SPECIAL MEETING NOTICE

TOM HAAG BUILDING ADDITION

TOM HAAG BUILDING ADDITION
441 BUSINESS PARK CIRCLE
STOUGHTON, DANE COUNTY, WISCONSIN
SITE PLAN

I have completed a review of the proposed building addition for Thomas Haag, 441 Business Park Circle, Lot 29, Business Park North - Plans received 10-25-12. As noted, additional information may be required to be provided or shown on the plan. A joint meeting is planned for Monday, October 29, 2012 of which you will receive notice.

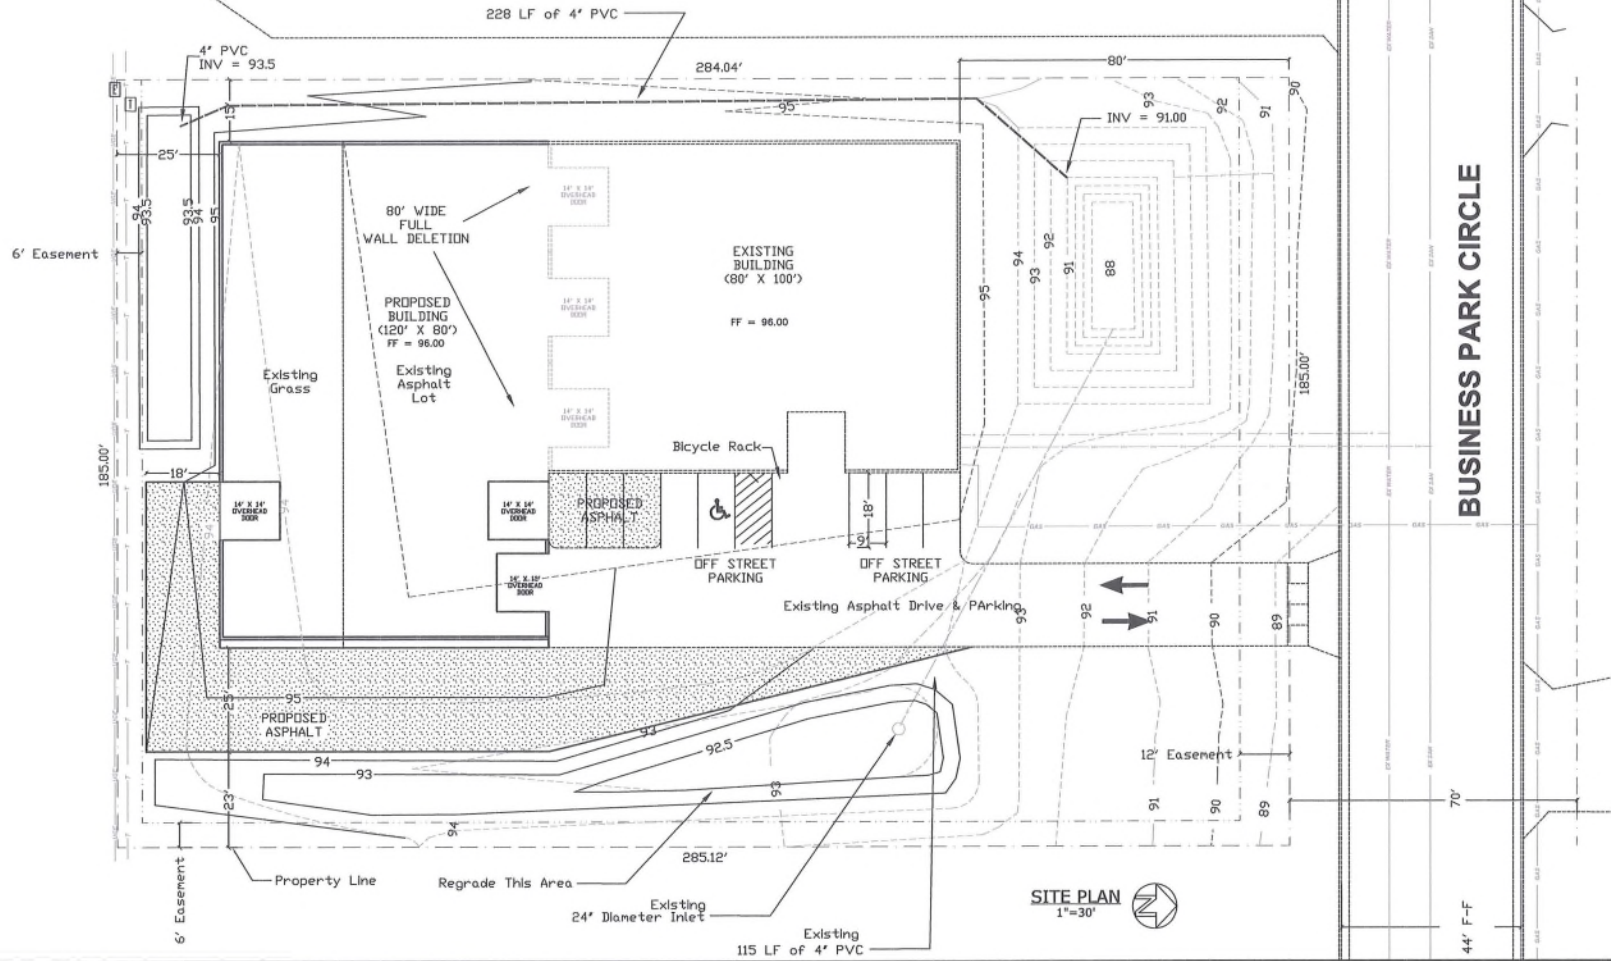
4. The parking requirement for an indoor storage use is one space per 2,000 square feet of gross floor area. **The building requires 9 parking spaces. Eight parking spaces are shown. See #9 below.**

9. **Section 78-704(14) offers a potential reduction in automobile parking spaces based on specific criteria. Information will need to be provided to meet this requirement. We recommend the Planning Commission approve the reduction in parking by one stall as presented.**

TOM HAAG BUILDING ADDITION
441 BUSINESS PARK CIRCLE
STOUGHTON, DANE COUNTY, WISCONSIN
EROSION CONTROL PLAN

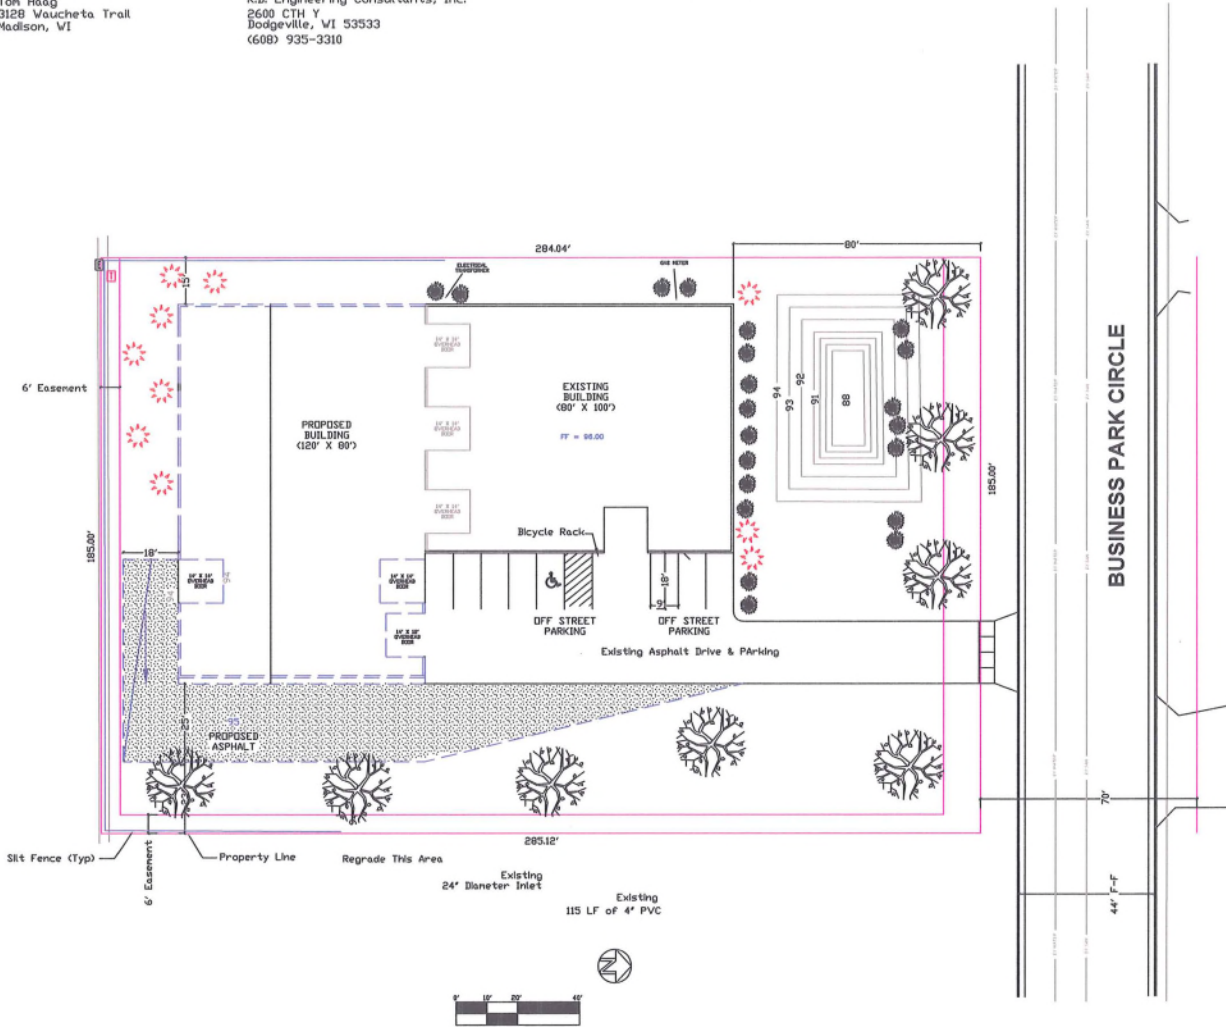
- d. Exterior Lighting. Plan provided.
 - e. Clearing, grading, and drainage plan showing proposed clearing limits, existing and proposed contours at two foot intervals. This requirement should be taken care of as part of the erosion control plan.

TOM HAAG BUILDING ADDITION
441 BUSINESS PARK CIRCLE
STOUGHTON, DANE COUNTY, WISCONSIN
LANDSCAPING PLAN

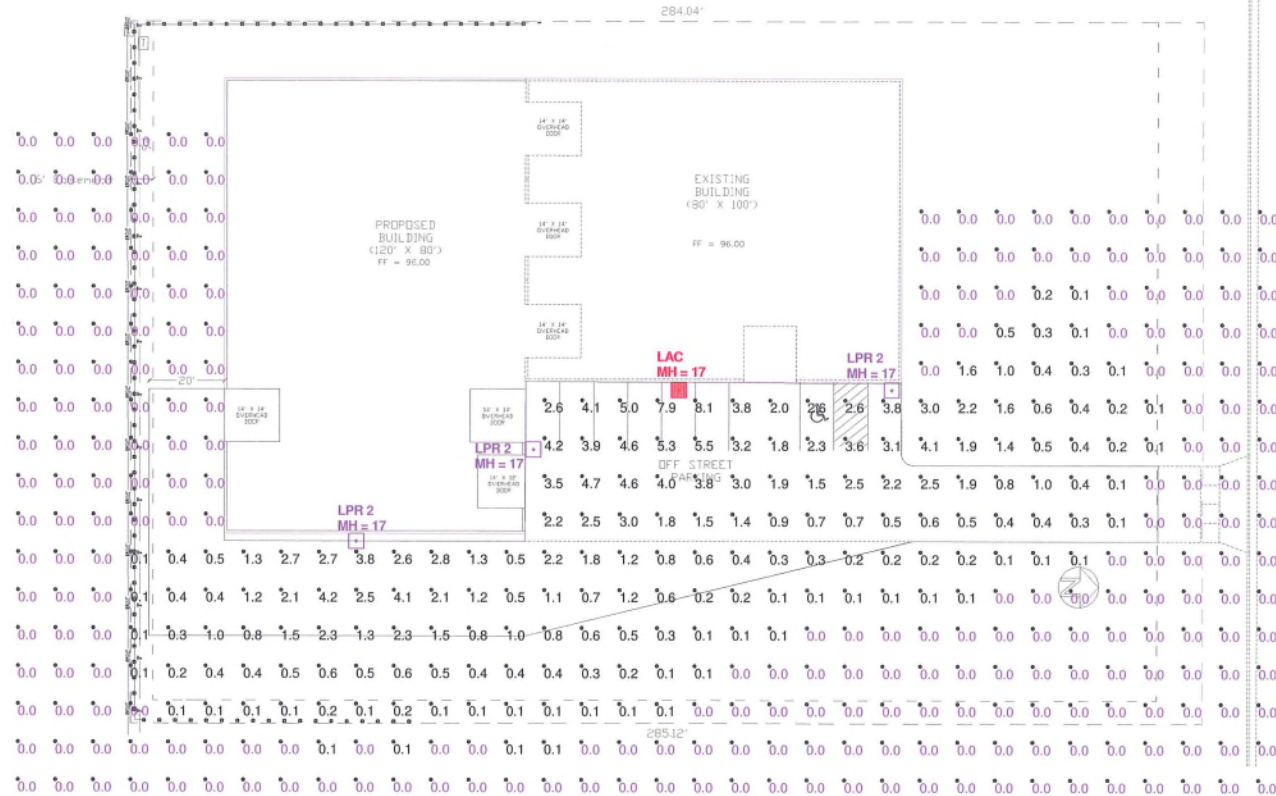
10. There are no bufferyard requirements when adjacent properties are the same zoning classification.
11. A landscaping plan will need to be provided that meets the requirements of article VI of the city zoning code for the building addition. Forty points of landscaping are required for each (prorated) 100 feet of newly added building foundation perimeter. Sixty points of landscaping are required for every newly added (prorated) 20 parking stalls or 10,000 square feet of pavement (whichever yields the greater landscaping requirement). These requirements have been met.
